Recall Bulletin

PRODUCT SAFETY RECALL

SUBJECT: Driver Front Airbag Inflator Failure

MODELS: 2013-2014 Chevrolet Cruze

3988952

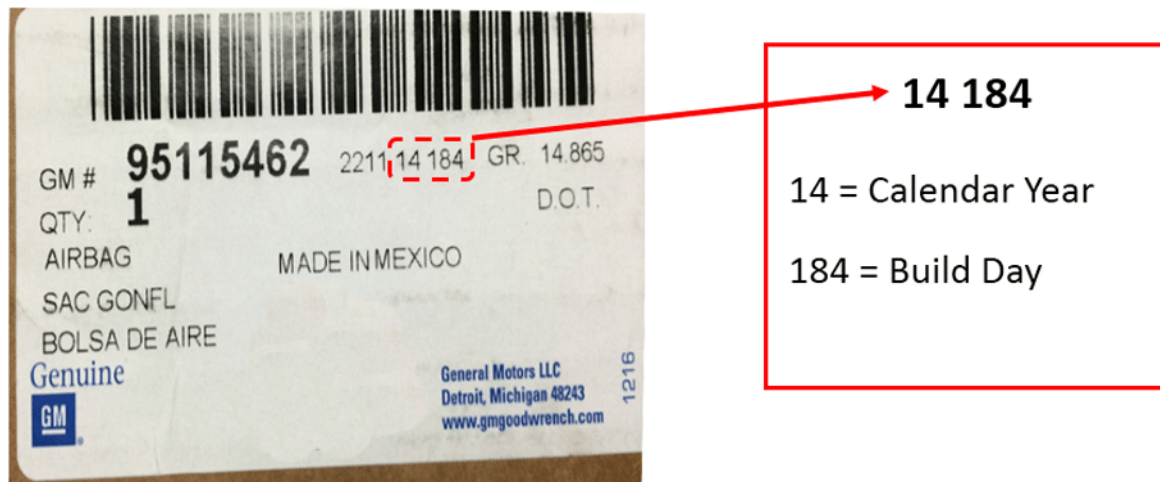
NOTE: The part inspection has changed from a “blue dot” verification to a confirmation of a Julian date on the box the module was shipped in.

2. **Before installation**, inspect the new replacement steering wheel airbag module **box**. A Julian date (shown circled in the example above) will be present on the label of the box the module was shipped in.

The date breakpoint of affected parts is JUNE 30, 2014. Parts purchased and received on, or prior to, June 30, 2014 are discrepant and should be returned. Parts received after June 30, 2014 are good.

IMPORTANT: The **AFFECTED** date codes for the above example would be: **14 181 and prior.**
